TENNESSEE TECHNOLOGY CORRIDOR DEVELOPMENT AUTHORITY

REPORT OF STAFF RECOMMENDATION

Meeting Date: 9/9/2019
File Number: 9-A-19-TOB
Applicant: HARLEY BITTLE
Request: BUILDING PERMIT

MPC01
 SITE LAYOUT PLAN
 DRAWING

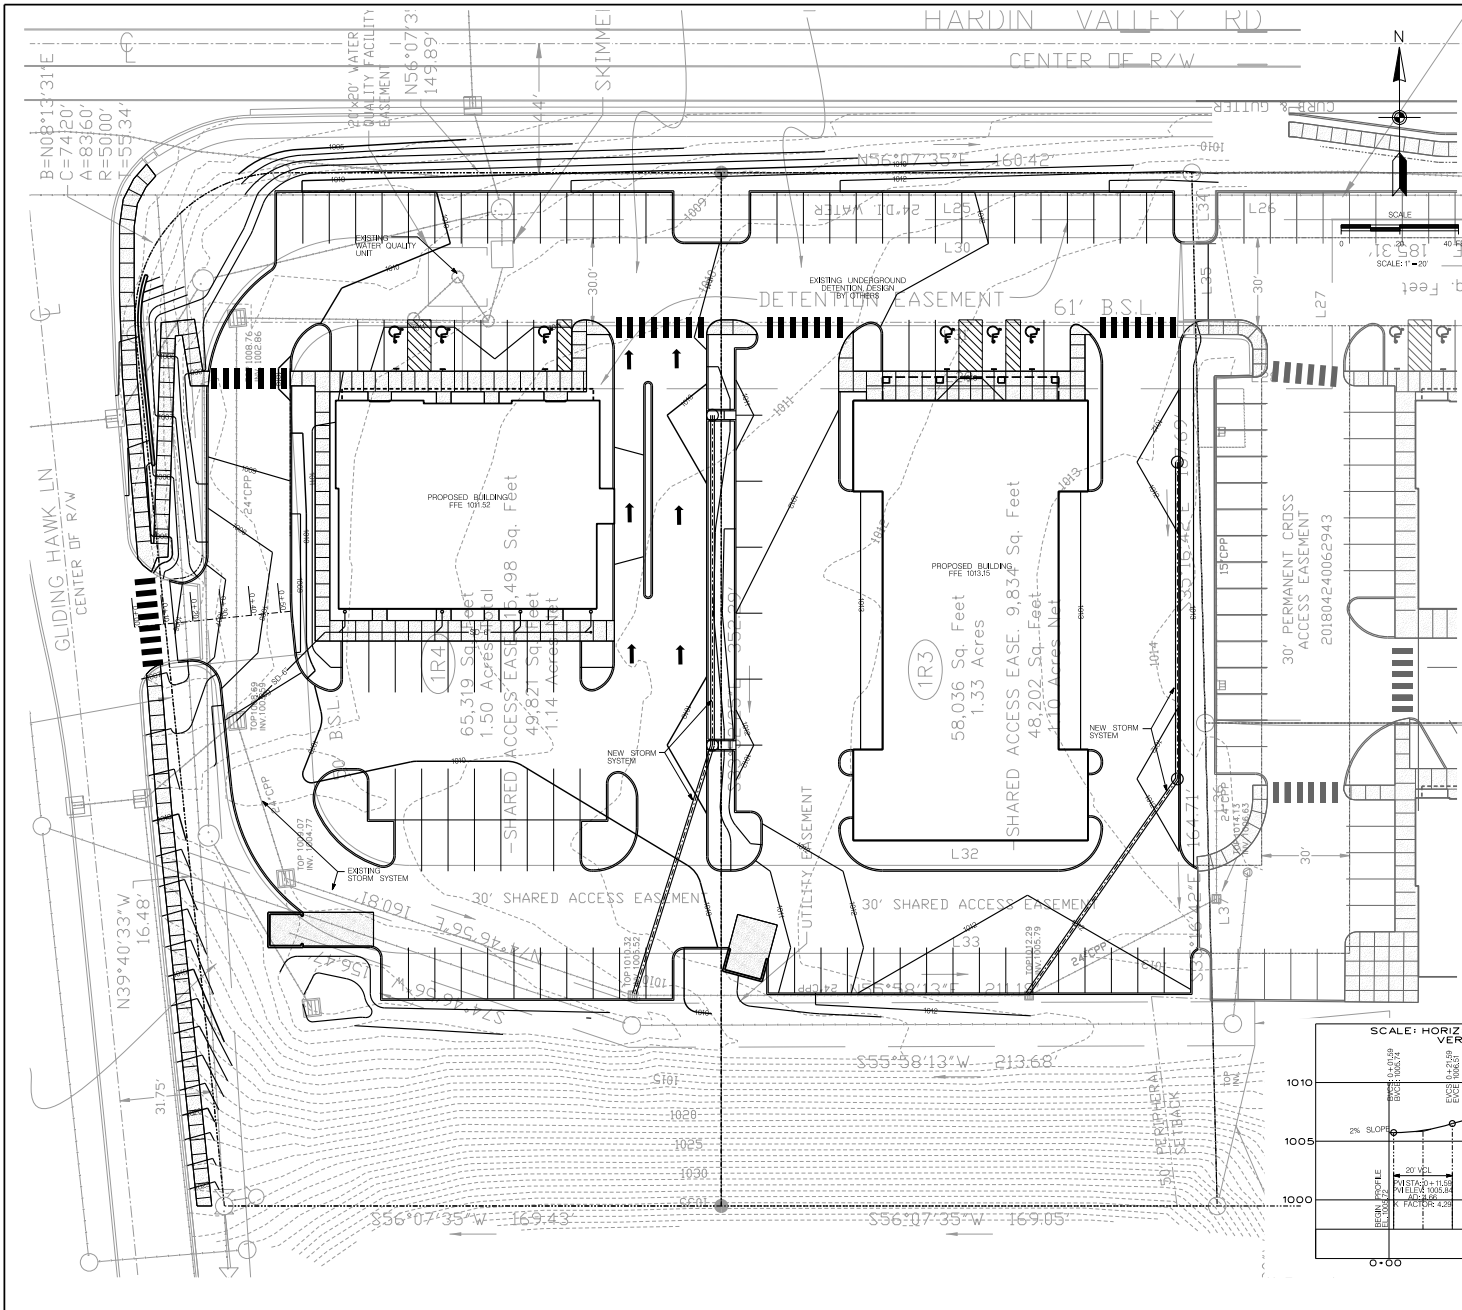
3) Under the Design Guidelines, the proposed tire center would be allowed a maximum of 36 parking spaces. The applicant is proposing a total of 45 parking spaces for this site which requires the approval of a waiver by the Board from the Design Guidelines for maximum parking spaces. In their waiver request, the applicant has identified that based on the number of service bays included in the building, their experience at other locations is that the proposed spaces are needed. Staff supports the requested waiver.

5) Access for the site will be out to Gliding Hawk Ln to the west, and the interior driveways for the retail center located on the east side of the site. There is no direct access out to Hardin Valley Rd. Sidewalk connections are proposed from the retail center to the east and the sidewalks that will be installed along Gliding Hawk Ln with a connection out to the sidewalks along Hardin Valley Rd.

| Waivers and Variances Requested: | Waiver to exceed the maximum number of parking spaces allowed for the tire sales and service center under the Design Guidelines (Design Guidelines Section 1.7.5) by allowing an increase from 36 spaces to 45 spaces as identified on the development plan. |

Staff recommends APPROVAL of the requested Waiver to exceed the maximum number of parking spaces allowed for the tire sales and service center under the Design Guidelines by allowing an increase from 36 spaces to 45 spaces as identified on the development plan.

Sheet Name:
Landscape Plan

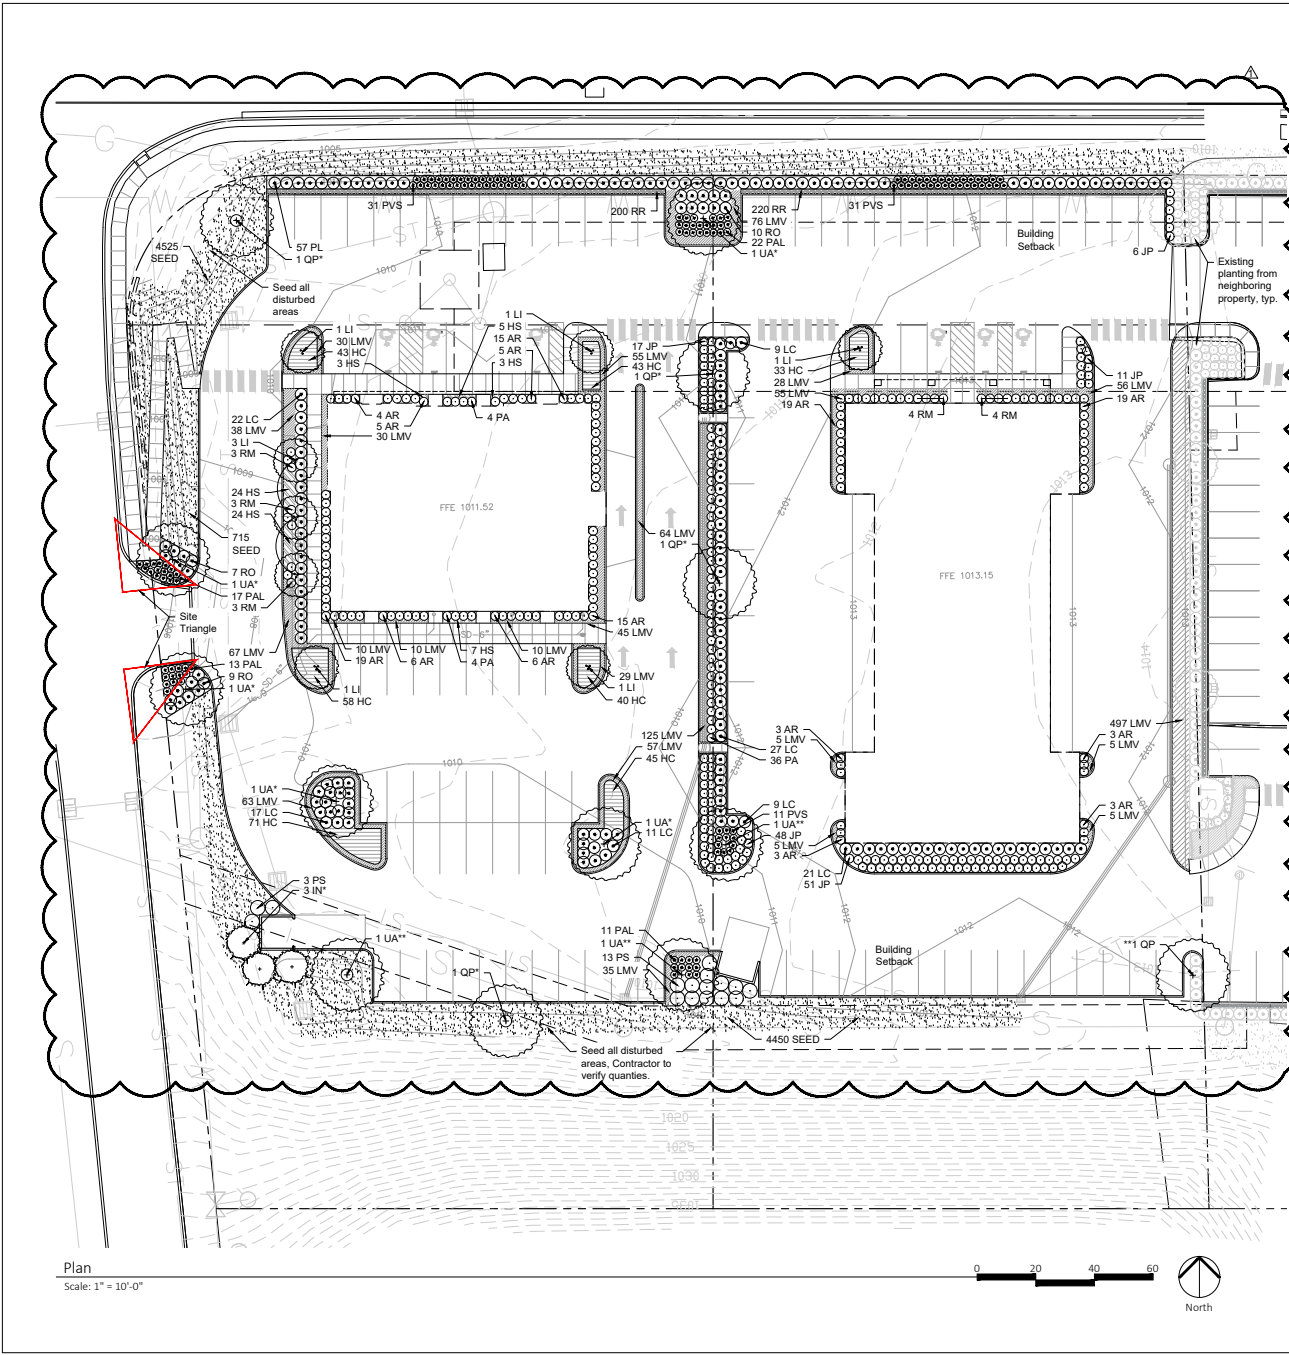
8) The landscape plan is consistent with the Design Guidelines.

- 3) Installing all landscaping as identified on the landscape plan within six months of the issuance of an occupancy permit for this project, or posting a bond with the Knox County Department of Engineering and Public Works to guarantee such installation. Landscaping shall be installed so as not to interfere with the sight triangles and visibility along public streets.

SITE ILLUMINATION PLAN, DETAILS

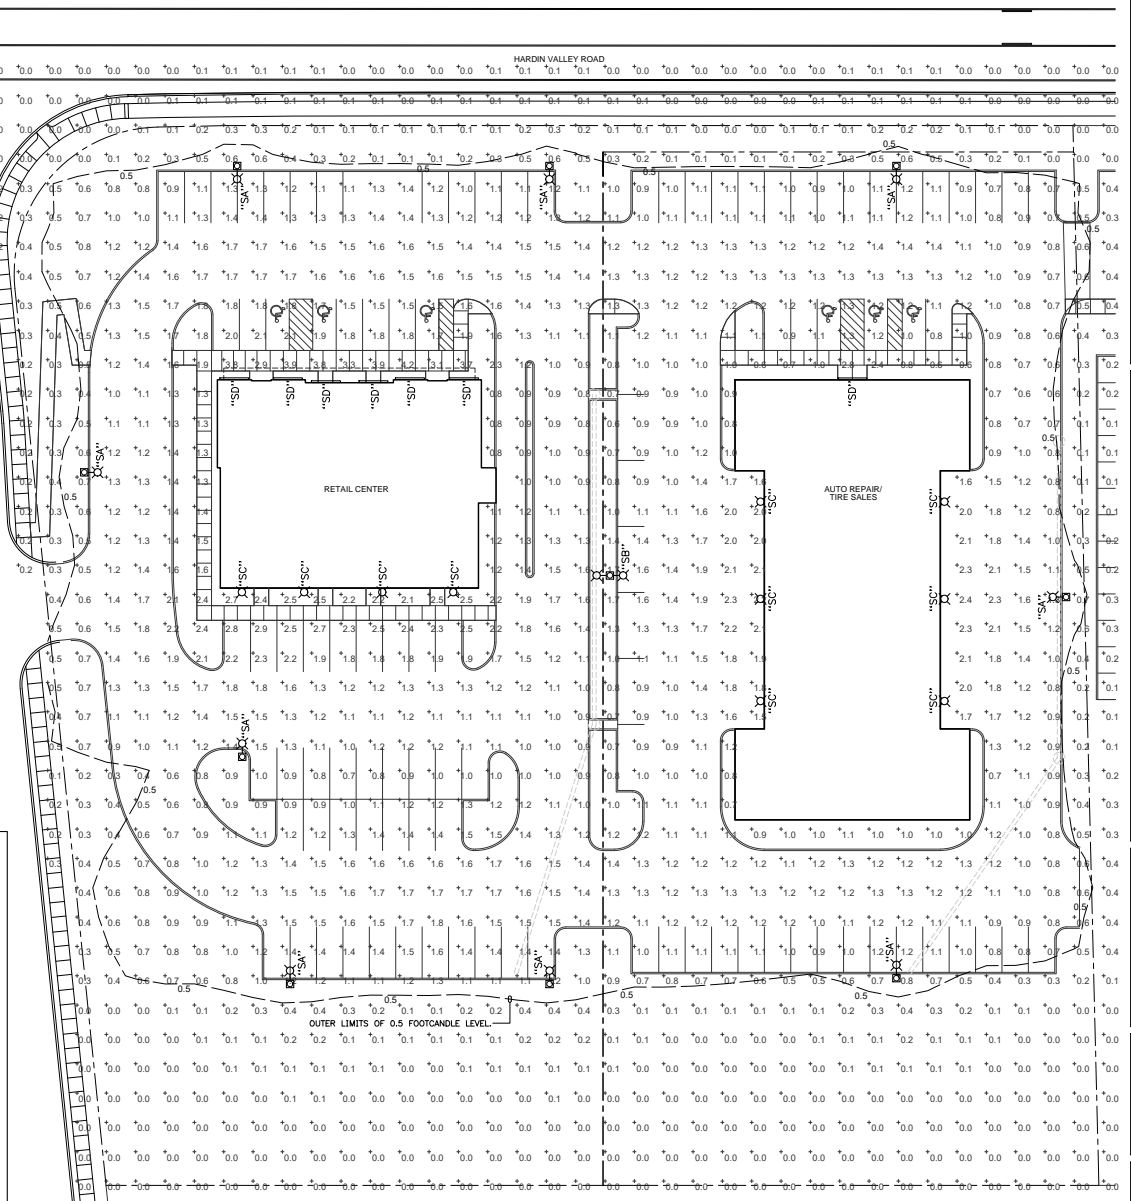
10) The proposed lighting for the parking lot and main building includes full cut-off LED fixtures. The proposed site lighting falls within the maximum intensity limits.
